# Errata for FM28V100

**Errata Number** 002  
**Date** Dec. 10, 2010  
**Product** FM28V100-TG (32-lead TSOP)

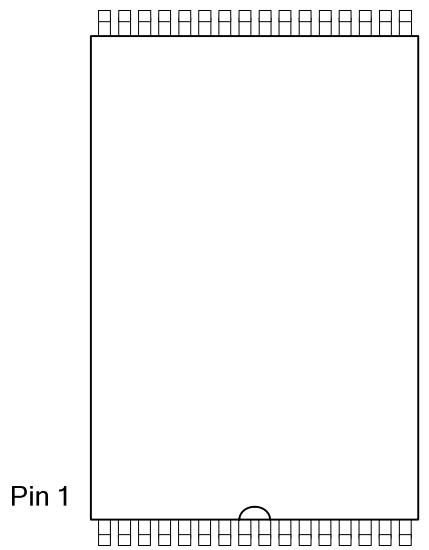
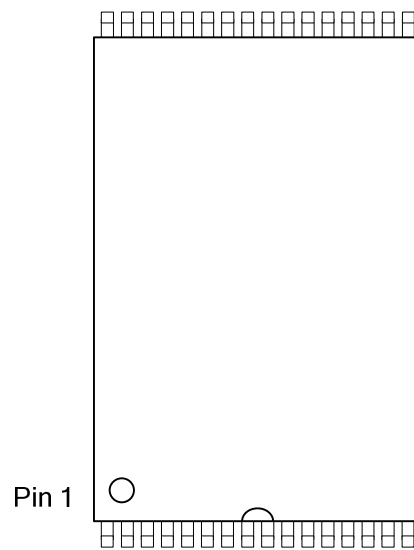
The 32-lead TSOP-I package does not have a pin 1 indicator in the corner of the package. The affected devices are marked with the date code 1001 through 1105. This problem has been fixed. The correct package marking with the pin 1 indicator dot will become available as date codes 1106 and higher.

Date Codes 1001 - 1105

Date Codes 1106 and up
